Senior Center – Restroom Rehab Project Addendum No. 001

This addendum is issued as part of the specifications and contract documents entitled:

CDBG FY2020 Senior Center – Restroom Rehab

MUNCIE DELWARE CTY SR CENTER BATHROOM IMPROVEMENTS

4 FLOOR PLAN
A101 1/4" = 1'-0"

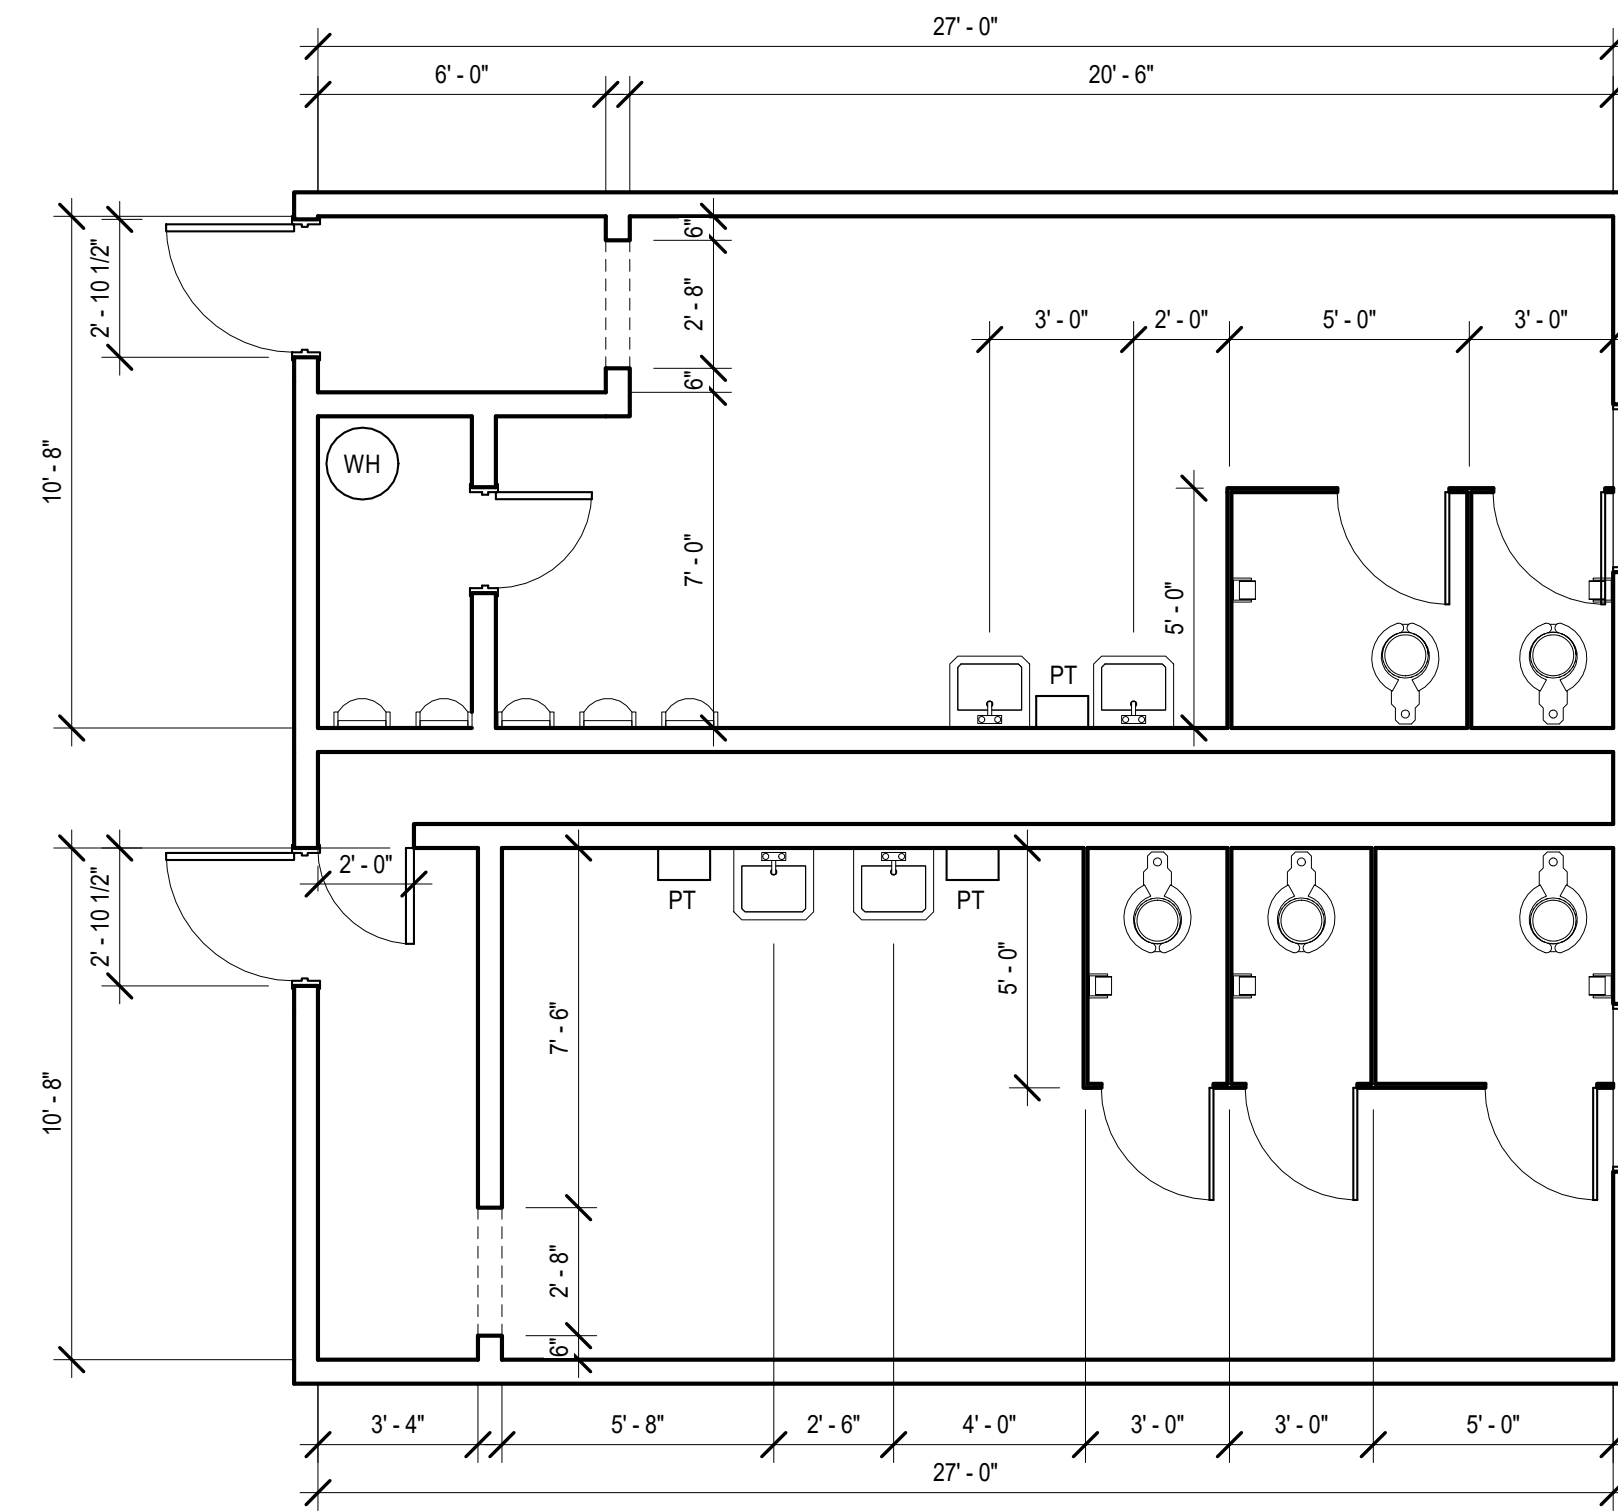
1. Changes to men's room light switch and water heater (see attached specifications and drawings).
2. Changes to women's room opening (see attached specifications and drawings).

1. Bid now to include a base bid and one alternate.
 - a. Base Bid: total project bid with changes shown in attached specifications and drawings.
 - b. Alternate 1: Removal of two urinals in the men's room. The urinals are shown in the attached specifications and drawings in the closeted area and are the northern-most urinals along the western wall.
